# Work Order ID 95454

Item Name: Crosstube Aft

# DART SERVICE INSTRUCTION

DRAWING NO. D212-664-241	TITLE CROSSTUBE ASSY (205/212 HI AFT)	REV. D	DART AEROSPACE LTD ENGINEERING ORDER		D.E.O. NO. D212-664-241-D-1	SHEET NO. SHEET 1 OF 2	SCALE NTS
DRAWN	CHECKED	MFG. APPR.	APPROVED	DE APPR.			
DATE 11.04.07	DATE 11.04.11	DATE 11.04.12	DATE 11/04/12	DATE 11.04.12

**FIGURE 1: SUPPORT INSTALLATION**

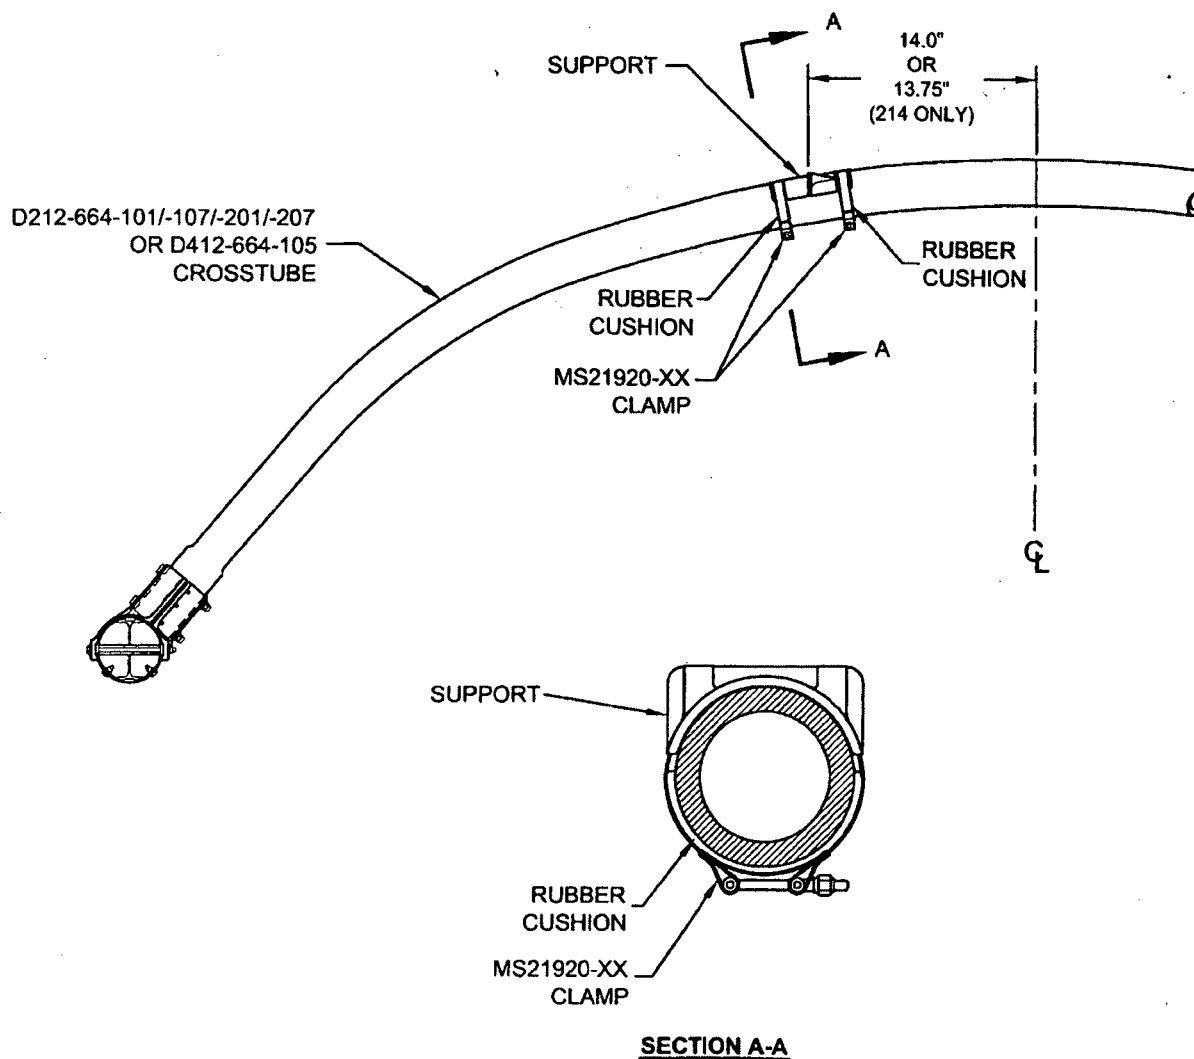
The supports on the following crosstubes are now installed using Proseal instead of Magnobond:

- 32.4.1 Locate the area on the crosstube for installation of support (see Figure 1 of this service instruction). For D212-664-101/-107/-201/-207 and D412-664-105 crosstubes, the outward face of the support tabs should be 14.0" (355mm) from the crosstube center for 204/205/210/412/UH-1 aircraft. For installation on 214B/B-1 aircraft, the outward face of the support tabs should be 13.75" (349mm). Ensure paint finish of crosstube is intact; touch up as required per Chapter 5 (5.3.9) of ICA-D212-664.

- 32.4.5 Apply a 0.04" to 0.07" thick layer of Proseal 890 Class B or AMS-S-8802 Class B sealant underneath applicable support and install support as shown in Figure 1 of this service instruction.

- 32.4.6 Install the clamps opposite to crosstube support as shown in section A-A of Figure 1. Install rubber cushions underneath each clamp around the bottom circumference of the crosstube up to the crosstube centerline. Torque clamps 80-100 in-lb (9.0-11.3 Nm). It is acceptable to use smaller or larger sized MS21920-XX clamps than those listed in ICA-D212-664, ensure that after torquing the clamps per this instruction, the nuts are in safety but not bottomed out

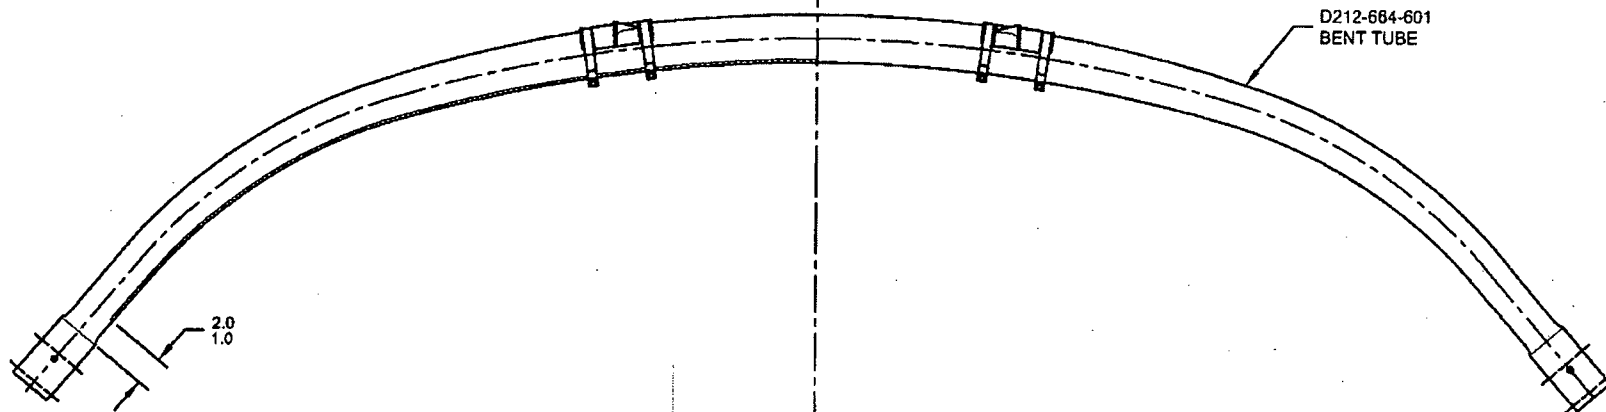
ADD AN INSPECTION WINDOW TO UNDERSIDE OF CROSSTUBE.

NOTES 2 OF SHEET 1 IS AMENDED AS FOLLOWS:

- 2) FINISH: CHEMICAL CONVERSION COAT PER DART QSI 005 4.1  
PRIME INSIDE AND OUTSIDE PER DART QSI 005 4.2  
MASK UNDERSIDE OF CROSSTUBE AS SHOWN (HATCHED AREA) AND  
PAINT OUTSIDE PER DART QSI 005 4.2  
REMOVE MASKING AND APPLY CLEAR COAT

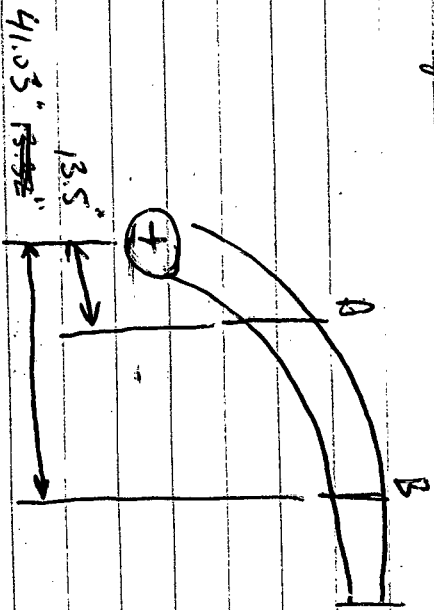
REPLACE MAGNOBOND WITH PROSEAL.

NOTE 12 & 15, SHEET 1 IS AMENDED AS FOLLOWS:

- 12) TO INSTALL D2940-1 SUPPORT: ABRASE MATING SURFACE OF SUPPORT AND CROSSTUBE WITH 180-GRIT SANDPAPER AND REMOVE RESIDUE WITH MEK (OR EQUIVALENT). APPLY A 0.04" TO 0.07" THICK LAYER OF PROSEAL 890 CLASS B-2 (OR AMS-S-8802 CLASS B-2) SEALANT TO MATING SURFACE OF SUPPORT.
- 15) TORQUE CLAMPS 80 TO 100 IN-LB. ENSURE AT LEAST 1.5 THREADS SHOWING IN SAFETY AND THAT NUT HAS NOT BOTTOMED-OUT AFTER TORQUING. **PRIOR TO PACKAGING, RE-CHECK TORQUE ON CLAMPS AFTER PROSEAL 890 SEALANT HAS CURED FOR 72 HOURS.**

- 12) INSTALL D2940-1 SUPPORT USING 0.03" TO 0.06" THICK LAYER OF MAGNOBOND 6398 TO THE SURFACE OF D2940-1 THAT WILL BE IN CONTACT WITH THE CROSSTUBE PER QSI 015. LET CURE FOR 12 HOURS AFTER INSTALLATION AND PRIOR TO PACKAGING.
- 15) TORQUE CLAMPS 80 TO 100 IN-LB. ENSURE AT LEAST 1.5 THREADS SHOWING IN SAFETY AND THAT NUT HAS NOT BOTTOMED-OUT AFTER TORQUING.
